# **UT to Cane Creek Restoration Project Year 5 FINAL Monitoring Report**

Subject: Task 11: Response Letter to DMS review comments regarding the Draft Year 5 Monitoring Report for the UT to Cane Creek Restoration Project (#95729)  
Cape Fear Basin – CU#03030002, Alamance County, North Carolina  
Service Contract No. 004951, DMS No. 95729, RFP No. 16-004357, Baker No. 132700

**Figure 5. Year 5 Cross-sections with Annual Overlays**

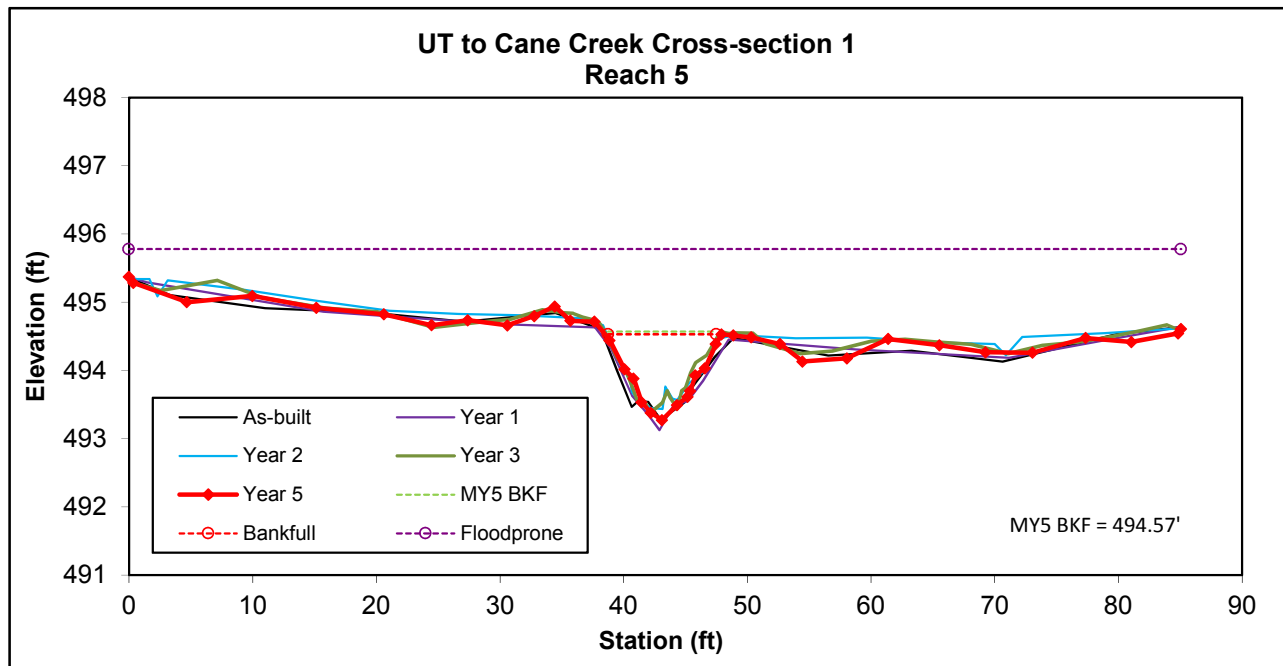
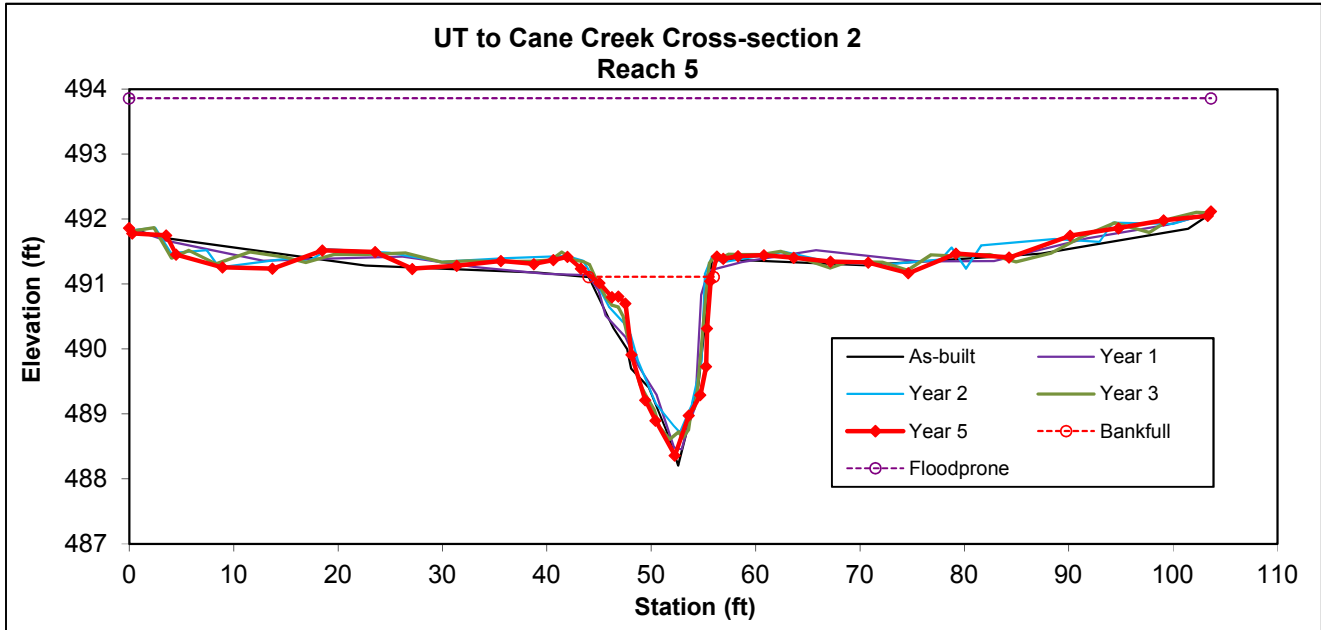
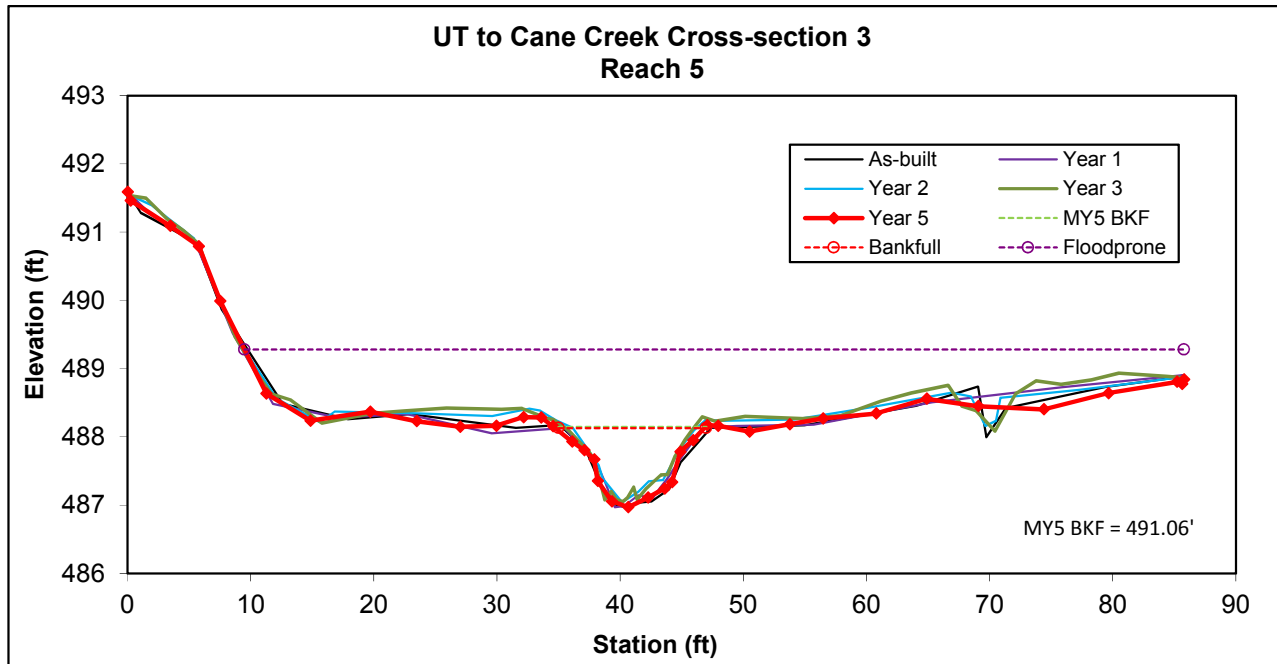
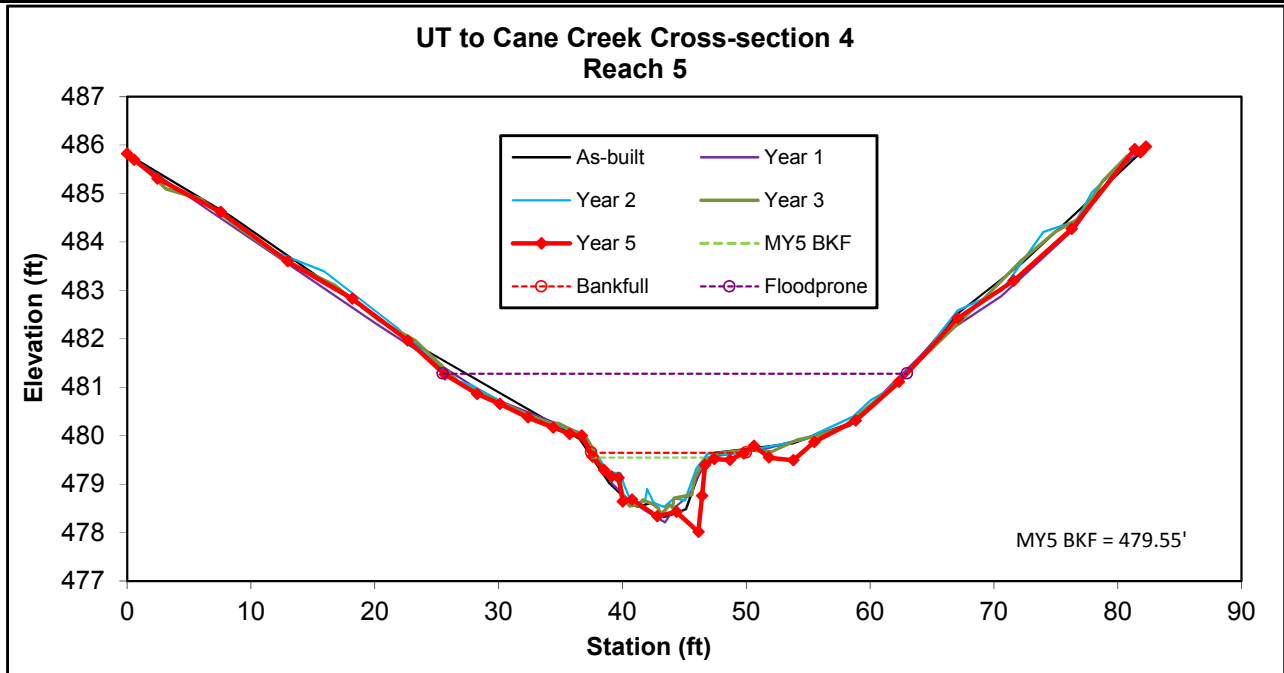
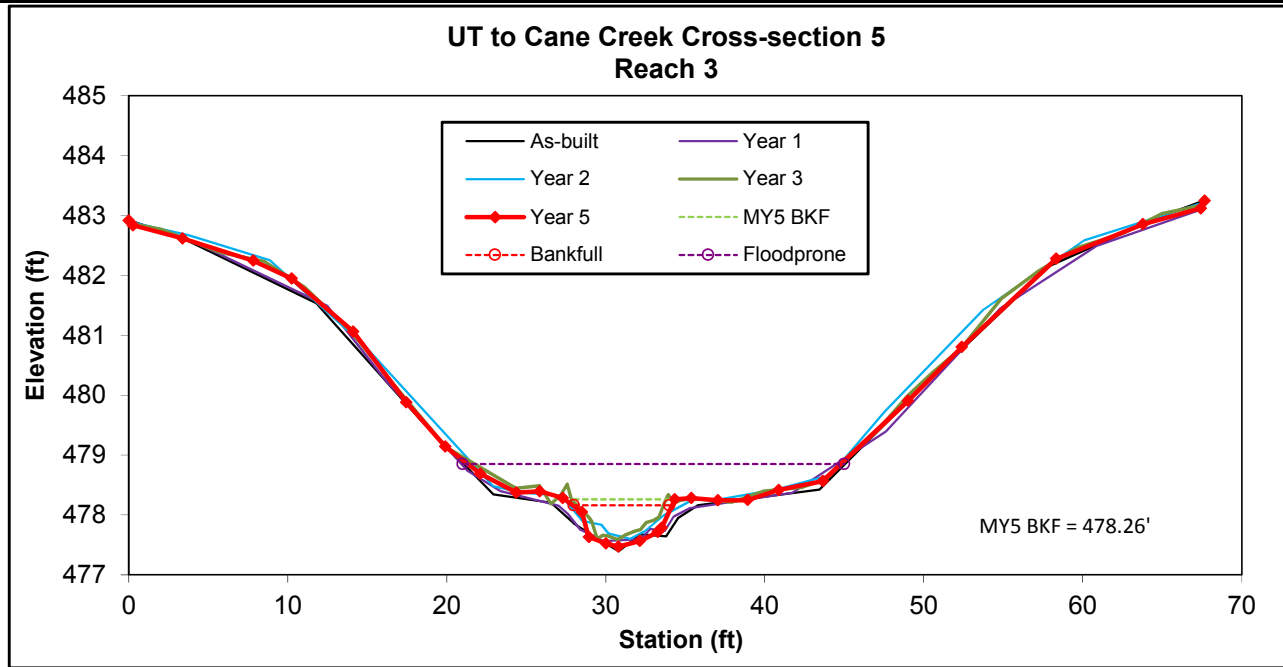
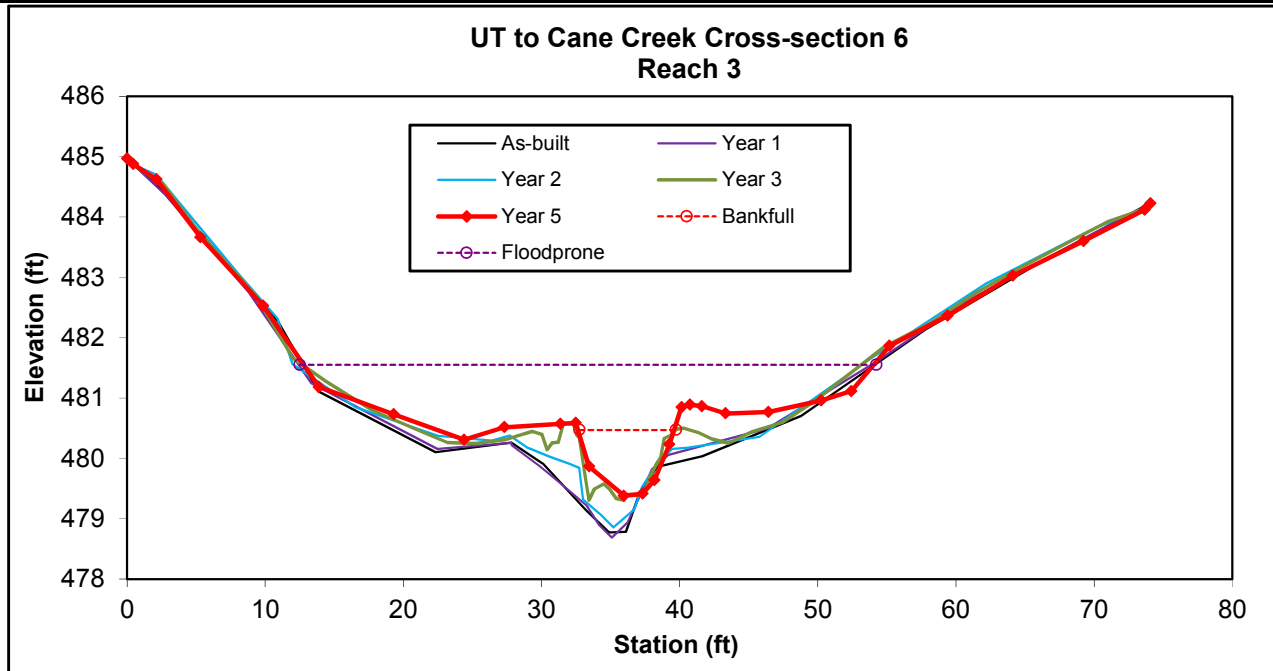
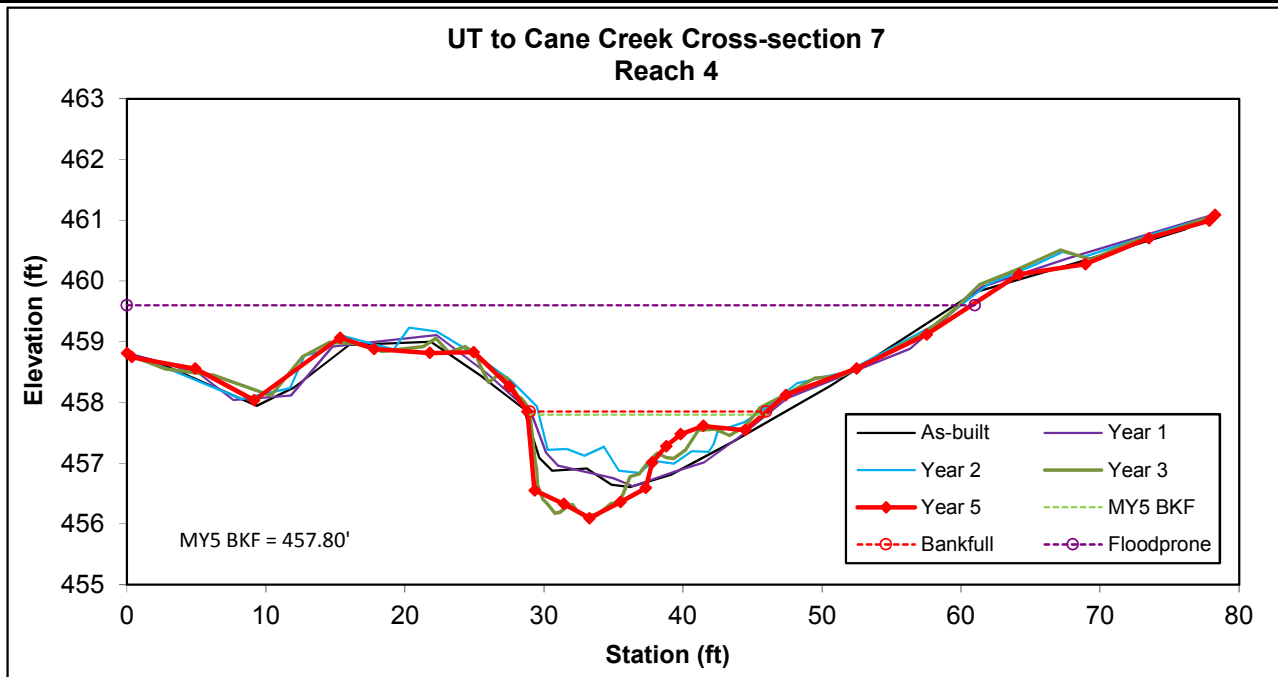
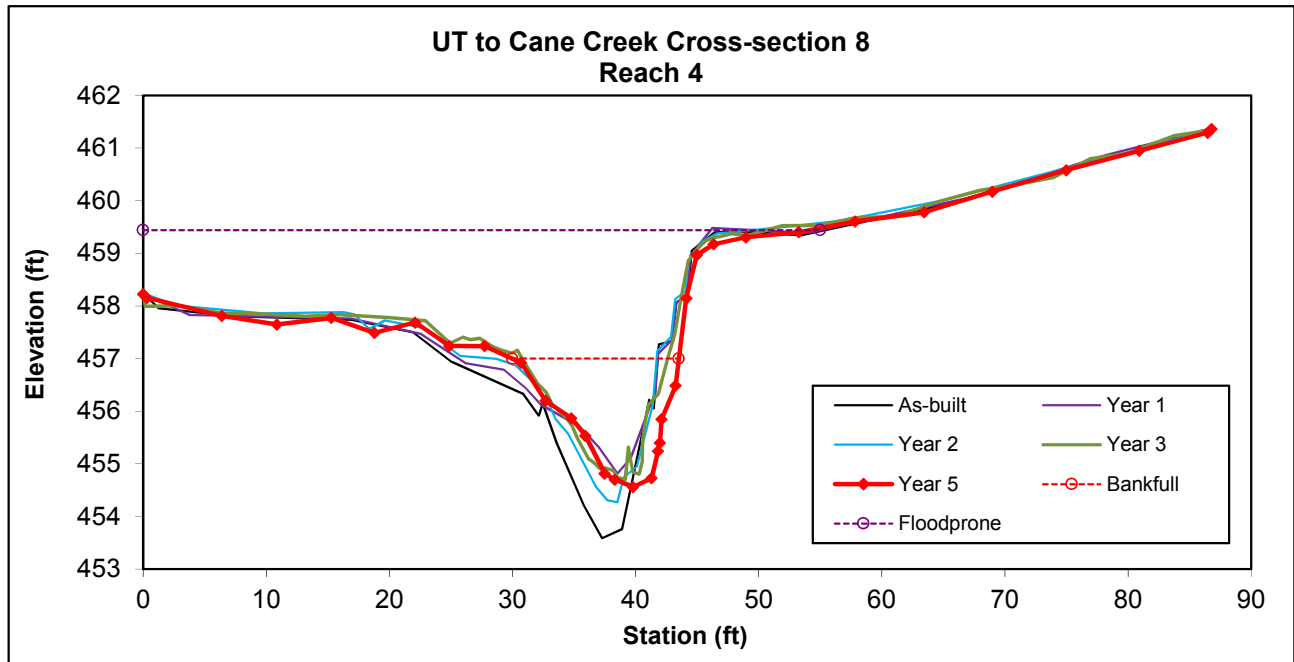
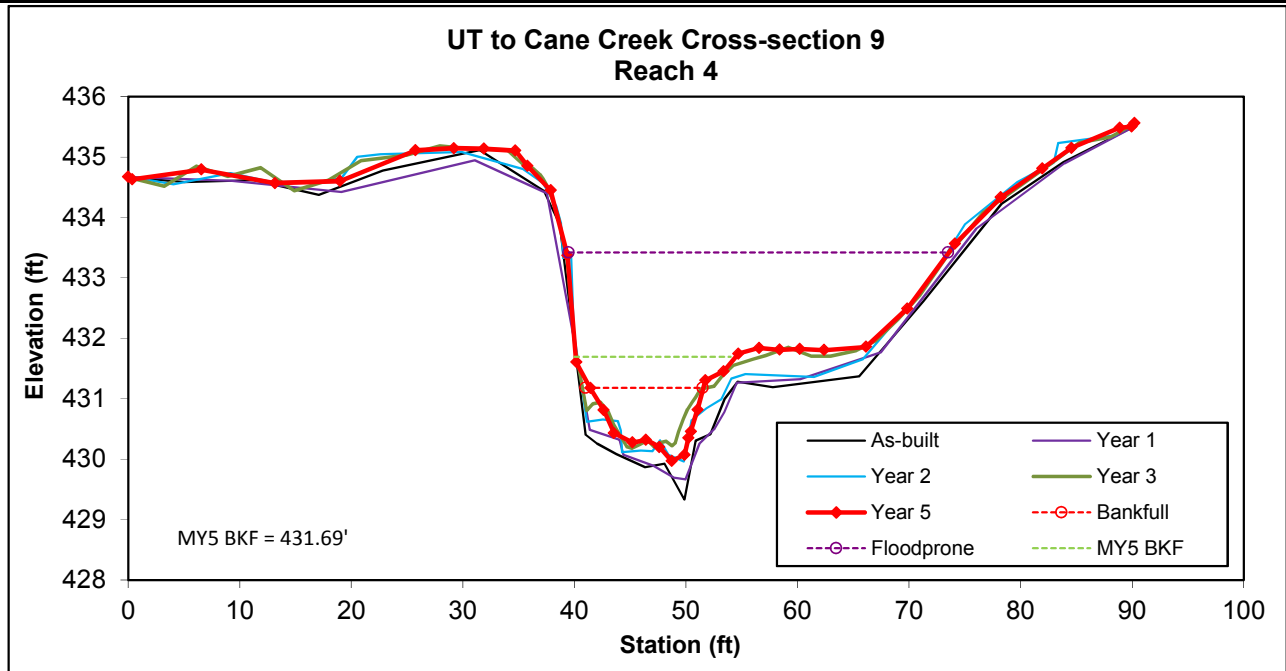
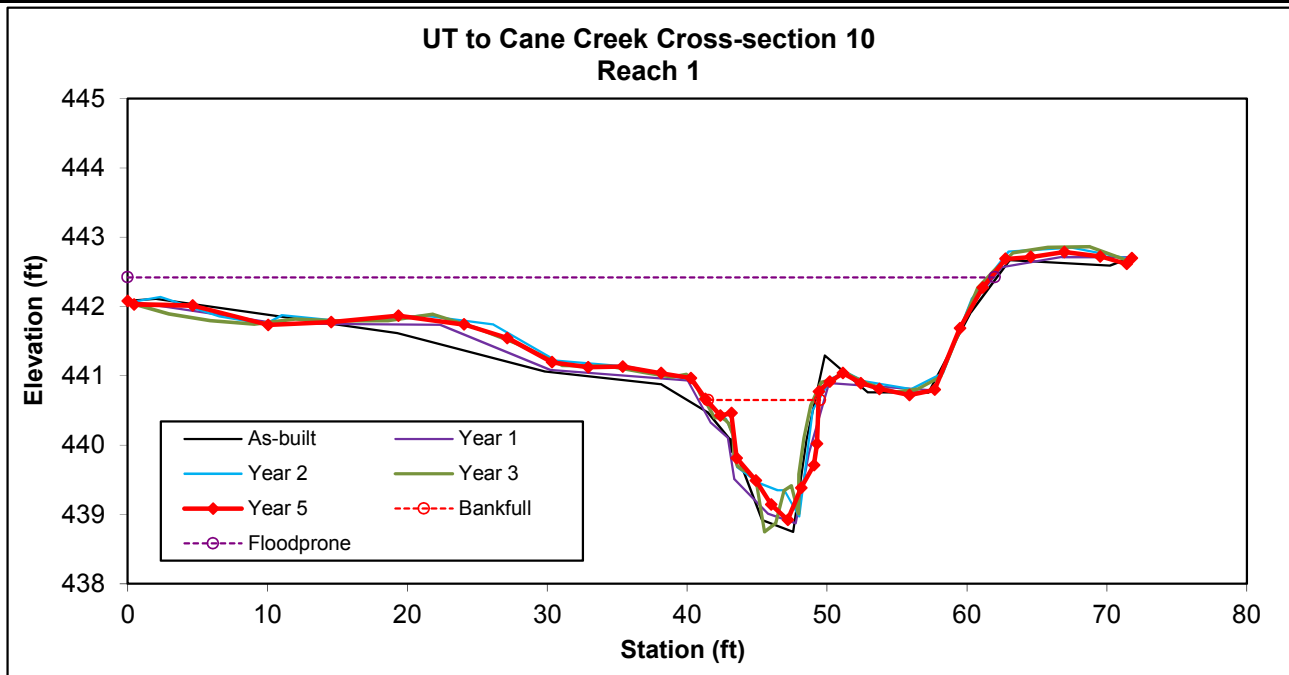
3. Appendix D, Table 11: During our review of the Bank Height Ratios (BHR) in Table 11, DMS staff performs a visual comparison of the MY5 data to As-Built/Baseline cross-sections. DMS noted/realized that by displaying the As-built Bankfull Cross-Sectional Area alone, the calculation for the BHR can be difficult to reconcile. We noted possible discrepancies in the BHR calculations for cross-sections 5, 9, 11 and 12 given this disconnect. Using the new BHR calculation methodology where the As-Built Bankfull Area is held constant, please display the Year 5 bankfull elevation as another data series just for the sake of clarity between the BHR calculation and the overlay. It appears that the BHR calculations were done correctly, but just please add the MY5 bankfull data series with its elevation for the sake of clarity to the reader.

**Response:** An additional data series was added to each cross-section figure showing the MY5 bankfull line (generated using the as-built bankfull area as per the recent DMS memo) as requested. The BHR calculations for the three listed cross-sections were re-checked again and were all confirmed as correct. With the new bankfull line shown, a visual comparison between it and the MY5 cross-section data certainly makes the BHR values appear to make intuitive sense.
